PCN-20190109 TE0808-04-* SPI Flash Change

Company	Trenz Electronic GmbH
PCN Number	PCN-20190109
Title	TE0808-04-* SPI Flash Change
Subject	BOM change
Issue Date	2019-07-15

This change affects Trenz Electronic TE0808-04 SoMs: TE0808-04-*

#1 Change SPI Flash from N25Q512A11G1240E to MT25QU512ABB8E12-0SIT

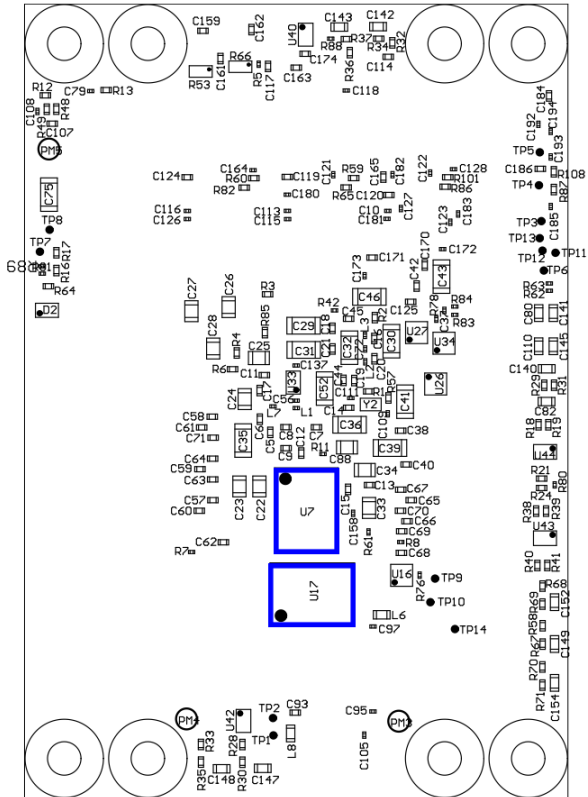
Type: BOM change

Reason: N25Q512A11G1240E became obsolete.

Impact: None. Both have same JEDEC ID BB20h and manufacturer ID 20h.

Locate Flash (U7, U17) on bottom side of PCB:

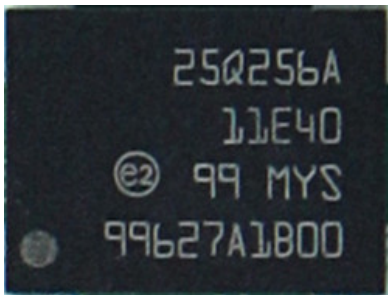
old	new
N25Q512A11G1240E	MT25QU512ABB8E12-0SIT
